# Access Compliance Report

## Public Rights-of-Way

### (Curb Ramps)

Intersection ID: 28079	Main Street: DELMAHOY_DR	Cross Street: PROVIDENCE_COUNTRY_CLUB_DR	Location: SW
ADA ID: 3661161D5A19	Ramp Type: Perp	Initial Pass/Fail: Fail	Overall Compliance: No
Severity Score: 12.5			
Codes/Mitigation Info/Possible Solution		Field Measurements/Component Compliance

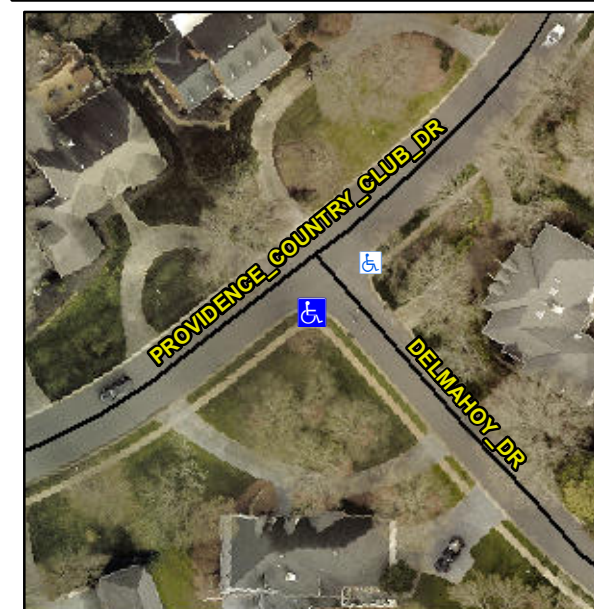
Surveyor Notes:

**N/A**

PROW/ADA:

**Not Found, R304.5.3**

Compliance	Description	Data	Compliance	Description	Data
N/A	Ramp Length (in)	54.0	Yes	Ramp Slope (%)	6.4
Yes	Ramp Width (in)	48.0	No	Ramp XSlope (%)	6.9
N/A	Flare Type LT	N/A	N/A	Flare Type RT	N/A
N/A	Flare Slope LT (%)	N/A	N/A	Flare Slope RT (%)	N/A
N/A	Flare Traversable LT?	N/A	N/A	Flare Traversable RT?	N/A
N/A	Landing Length (in)	N/A	N/A	DWS Provided?	N/A
N/A	Landing Width (in)	N/A	N/A	DWS Contrast?	N/A
N/A	Landing Slope (%)	N/A	N/A	DWS Length (in)	N/A
N/A	Landing X Slope (%)	N/A	N/A	DWS Full Width?	N/A
N/A	Landing Curb? (Y/N)	N/A	N/A	DWS Offset (in)	N/A
N/A	Shared Landing?	N/A			
N/A	Gutter Ponding?	N/A	N/A	Gutter Slope (%)	N/A
N/A	Gutter Lip Ht (in)	N/A	N/A	Gutter X Slope (%)	N/A
N/A	Painted X Walk1?	No	N/A	Painted X Walk2?	N/A
	X Walk 1 Direction	To NE		X Walk 2 Direction	N/A
N/A	X Walk 1 Width (in)	N/A	N/A	X Walk 2 Width (in)	N/A
	X Walk 1 Slope (%)	4.5		X Walk 2 Slope (%)	N/A
	X Walk 1 X Slope (%)	1.2		X Walk 2 X Slope (%)	N/A

Possible Solutions:

**Remove & Replace Entire Ramp.**
